## LAND USE APPLICATION SUMMARY

*Property Location:* 2910 - 2936 Pillsbury Avenue South  
*Project Name:* Karmel Plaza and Square  
*Prepared By:* Andrew Liska, City Planner, 612.673.2264  
*Applicant:* Basim Sabri, Karmel Properties, LLC  
*Project Contact:* Scott Nelson, DJR Architecture Inc.  
*Request:* Additions to the 1<sup>st</sup>, 2<sup>nd</sup>, 3<sup>rd</sup>, and 4<sup>th</sup> floors  
*Required Applications:*

**5 WEST (PLEASANT) ELEVATION**  
 1/16" = 1'-0"

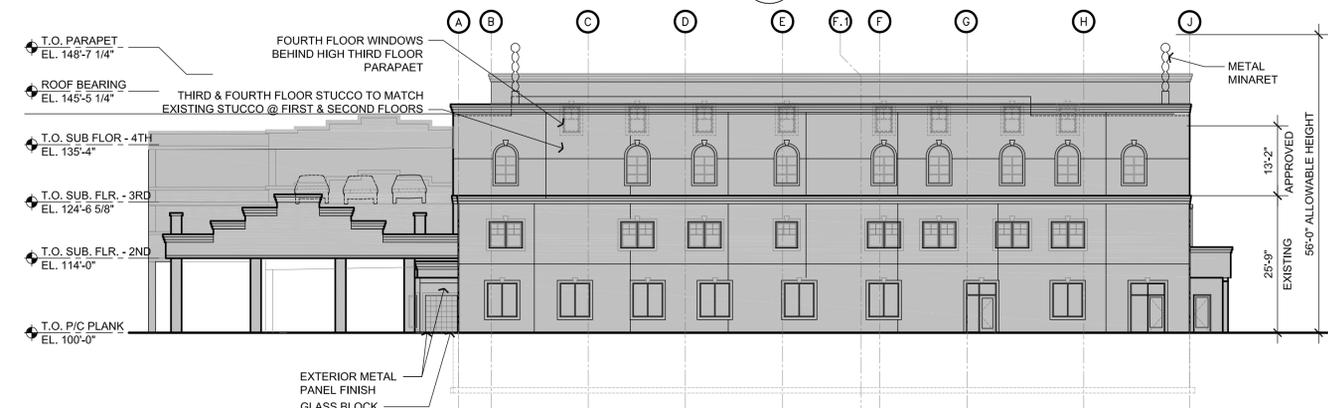
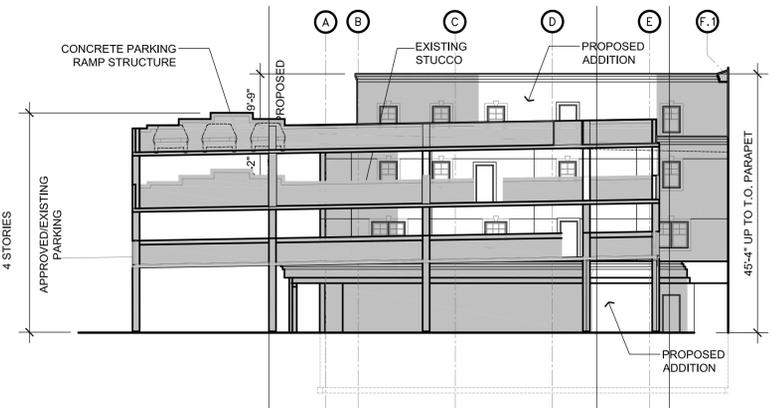
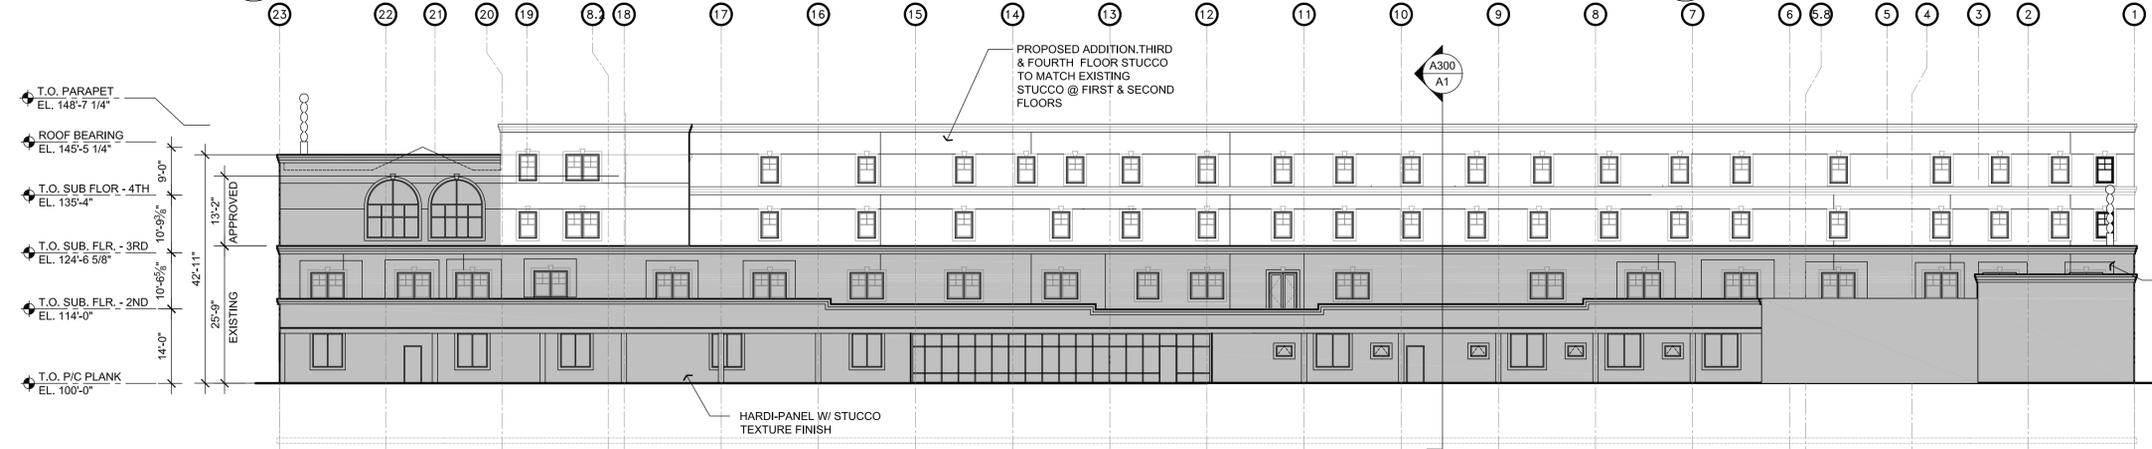
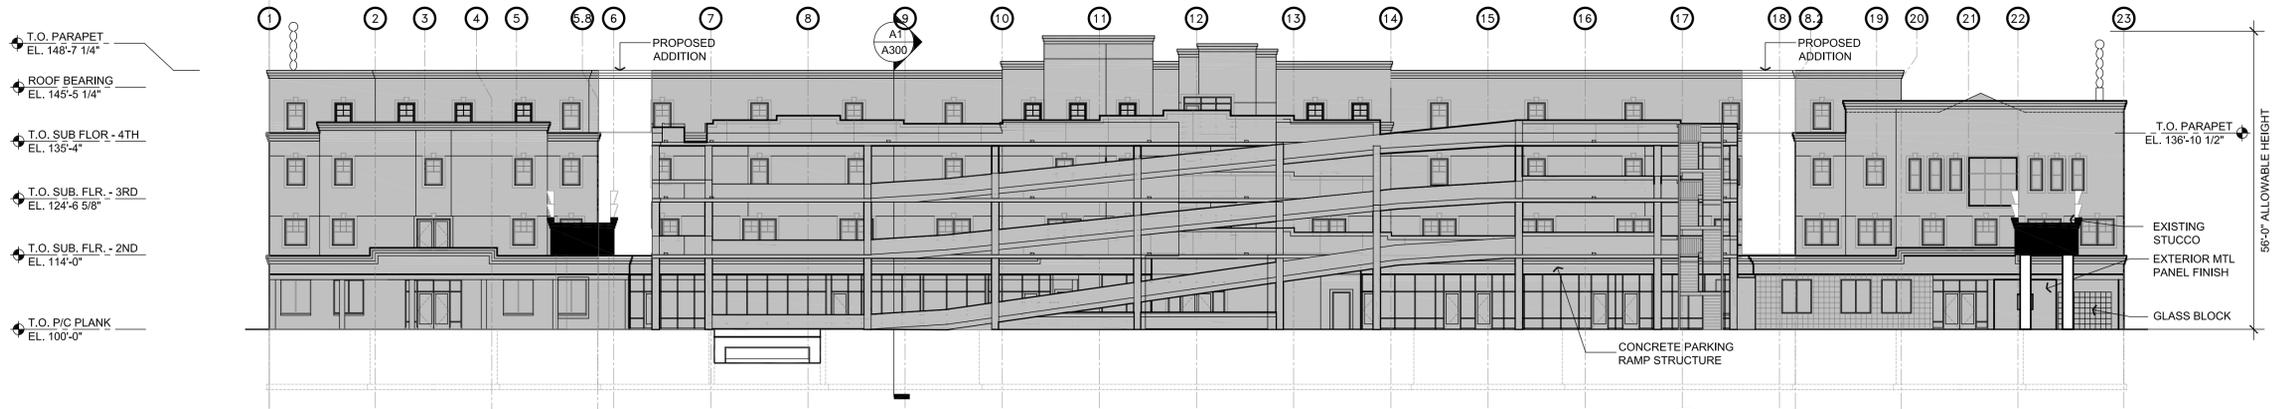
- The applicant will need to add window coverage to the west elevation 3<sup>rd</sup> floor as the proposal demonstrates 8.9% coverage; 10% coverage is the minimum.

- **Windows for the 3<sup>rd</sup> Floor facing Pleasant Avenue:** Alternative compliance is requested for the 3<sup>rd</sup> floor walls facing Pleasant Avenue. No alternatives are proposed and it is not infeasible to meet these requirements therefore staff is recommending that the Planning Commission not grant alternative compliance.

# KARMEL PLAZA (PROPOSED)

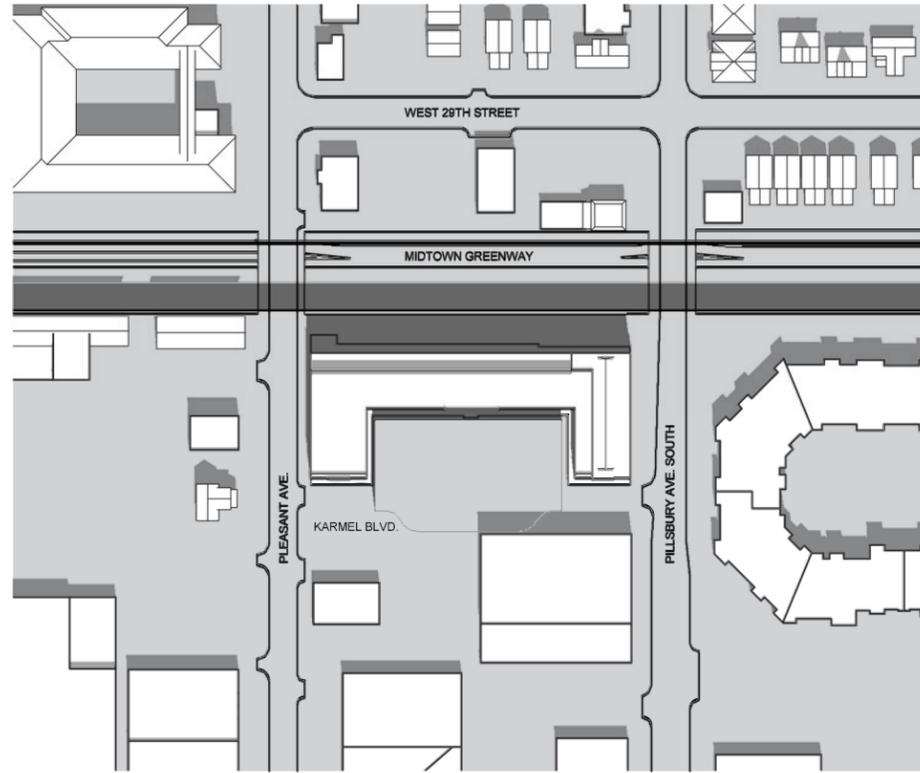
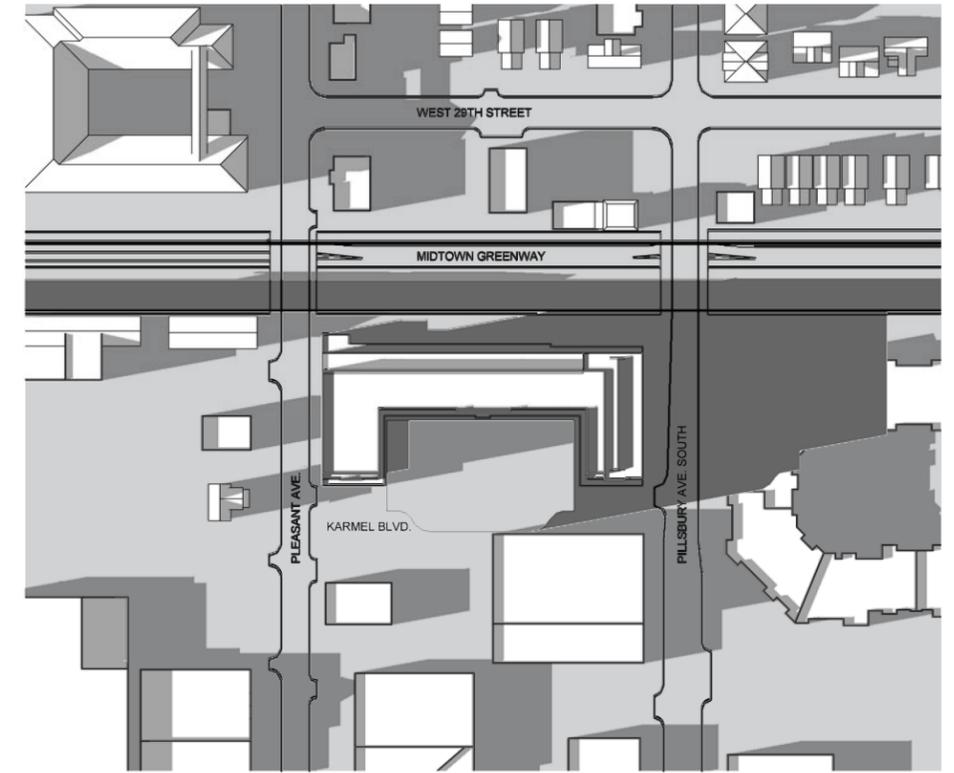
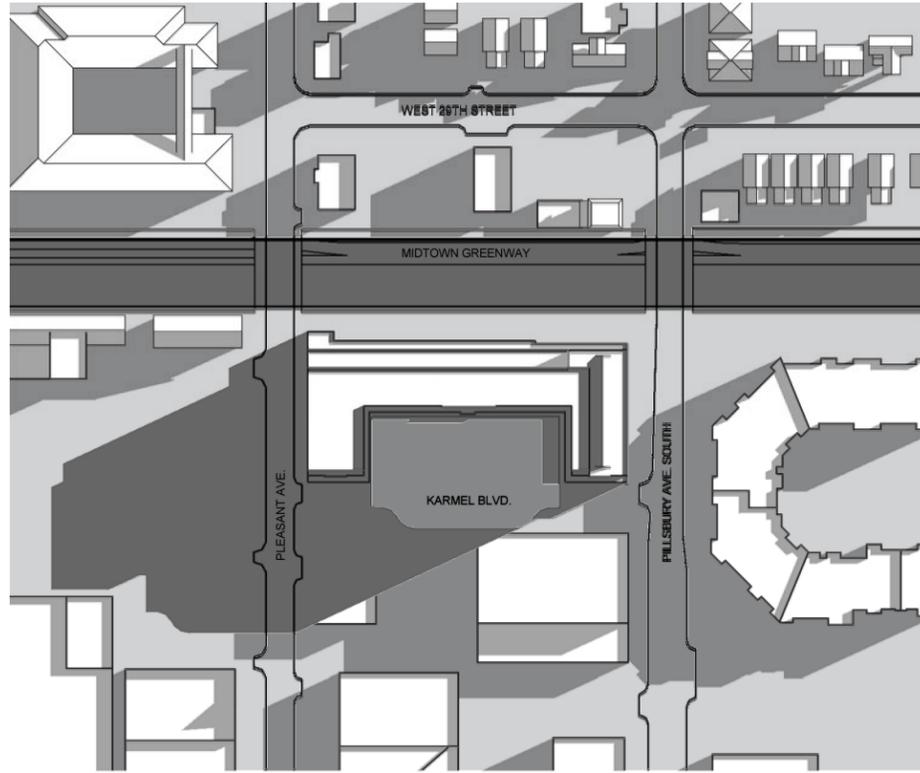
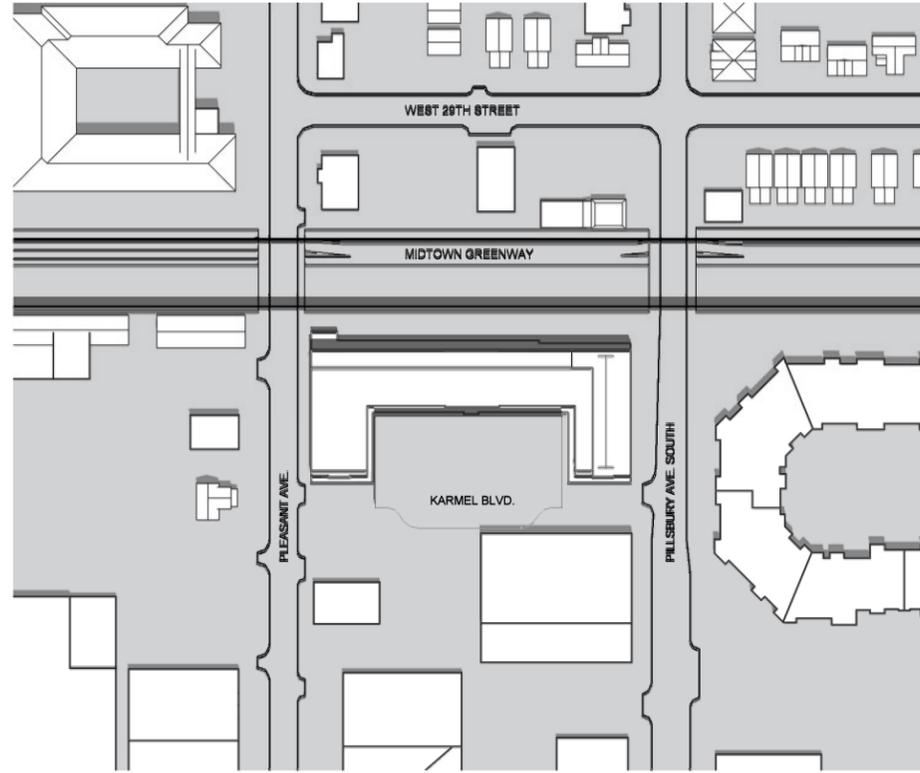
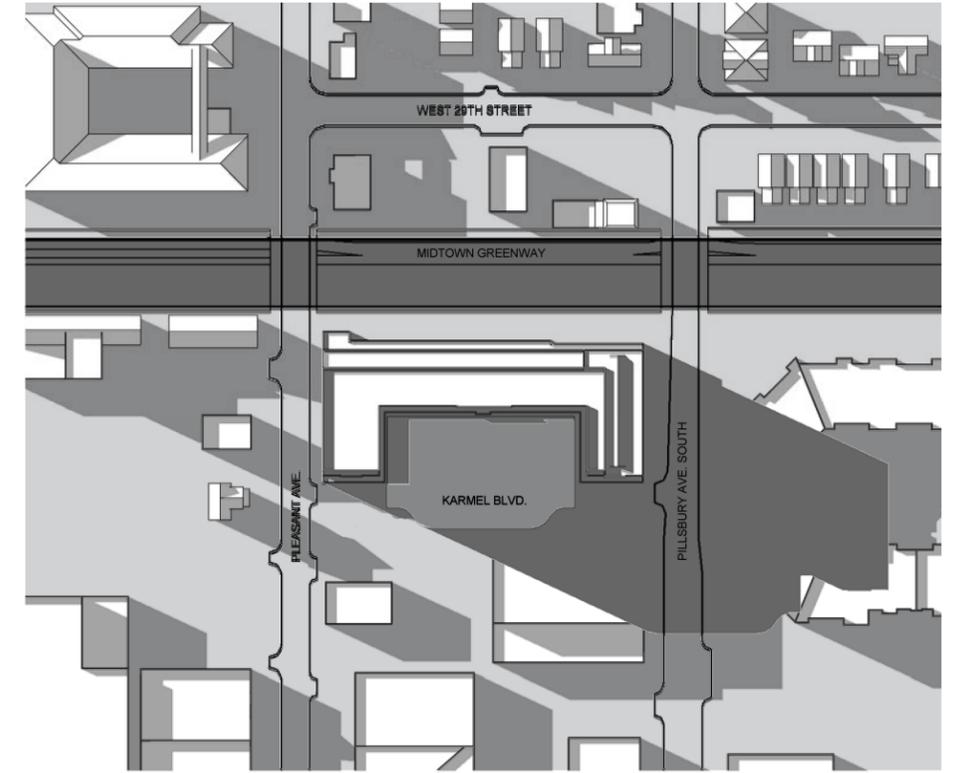
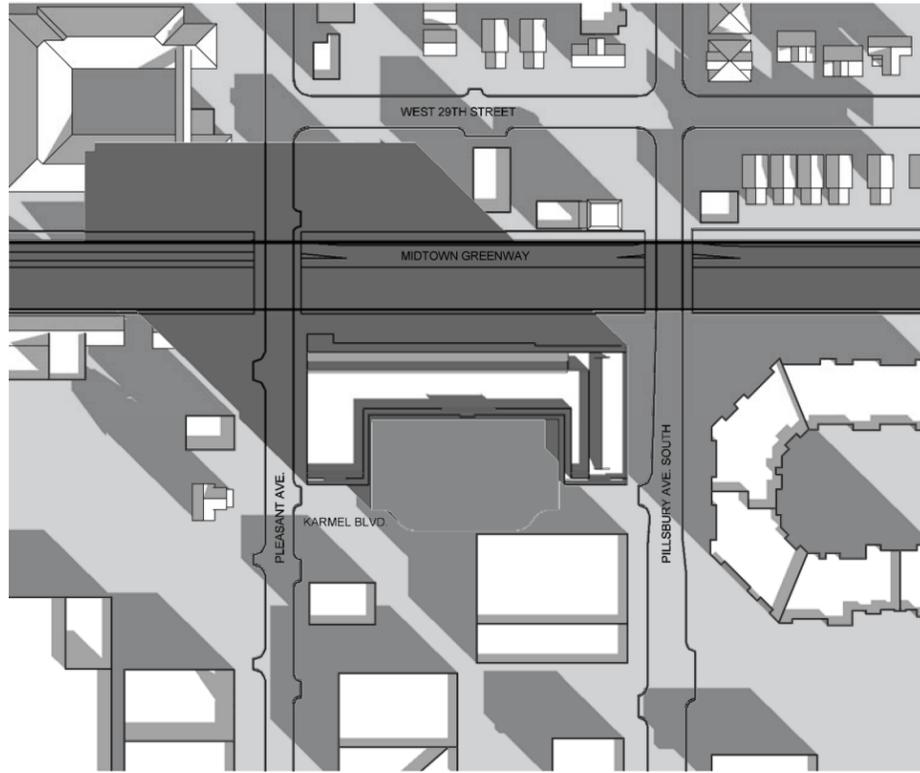
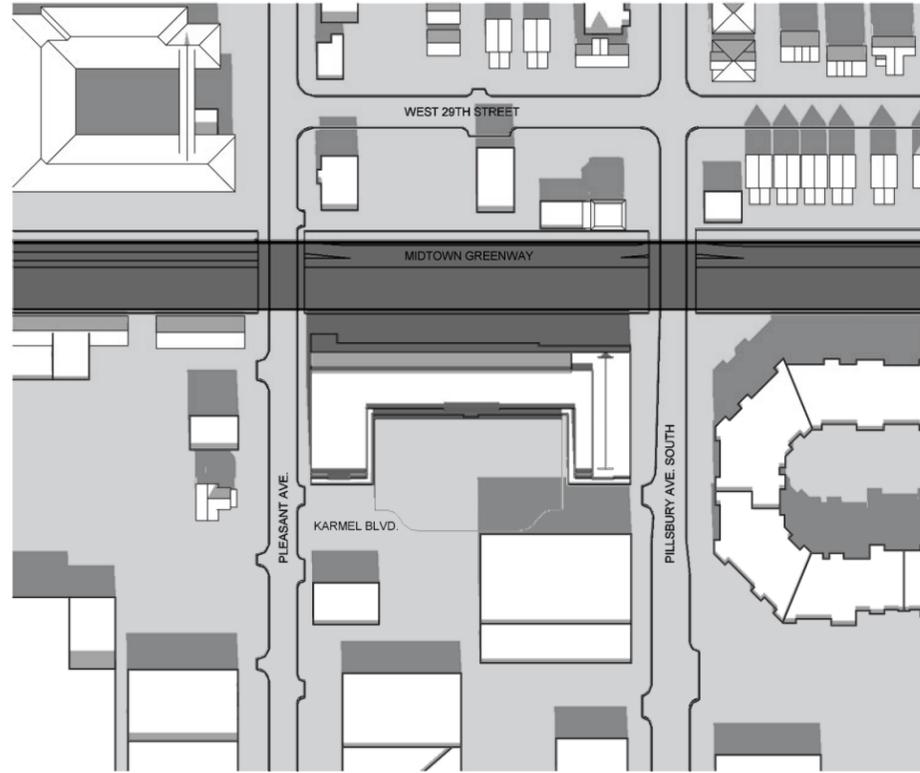
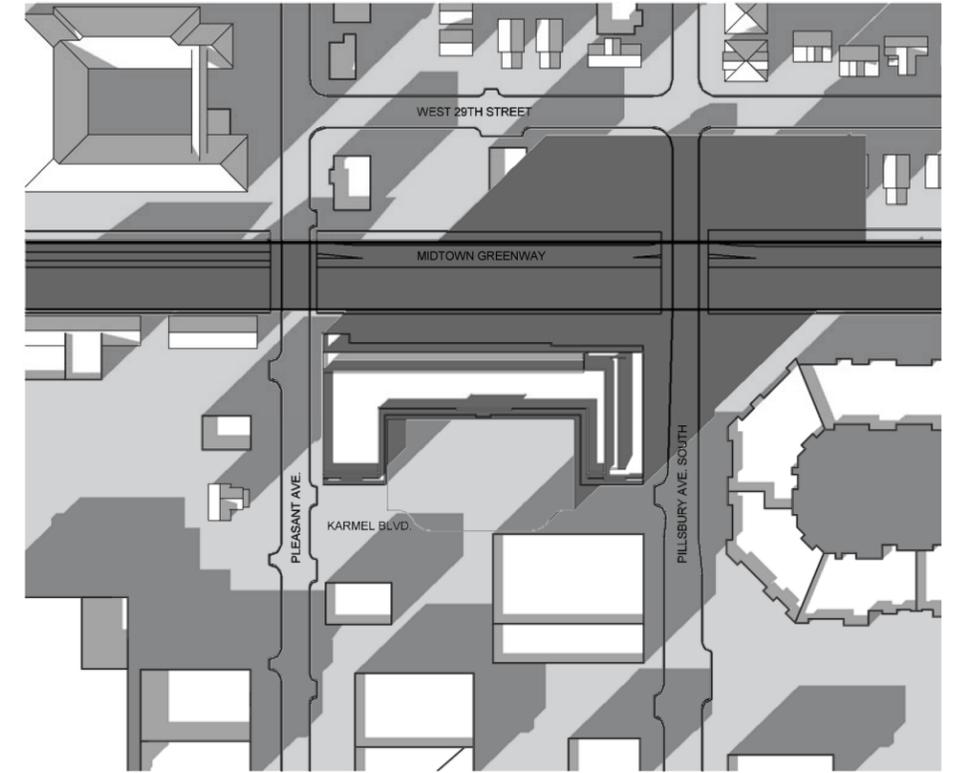
- The provided shadow study does not demonstrate the 65 foot previously approved portion of the easterly wall. The shadow study should demonstrate increased shadowing to the east side due to the increased bulk on the northerly side.

*Staff comment:* The proposed 3<sup>rd</sup> and 4<sup>th</sup> floor expansions to the north side of the structure will increase the shadowing on the Midtown Greenway. On page 6 above, the shadowing is analyzed as is a demonstration of other buildings along the south side of the Midtown Greenway relating to height, setbacks, the overall length of the structure and similar findings. The cross-sectional shadow study demonstrates minimal increased shadowing of the Greenway associated with the proposed 3<sup>rd</sup> floor addition. The proposed 4<sup>th</sup> floor addition does significantly increase the shadowing of the Greenway.
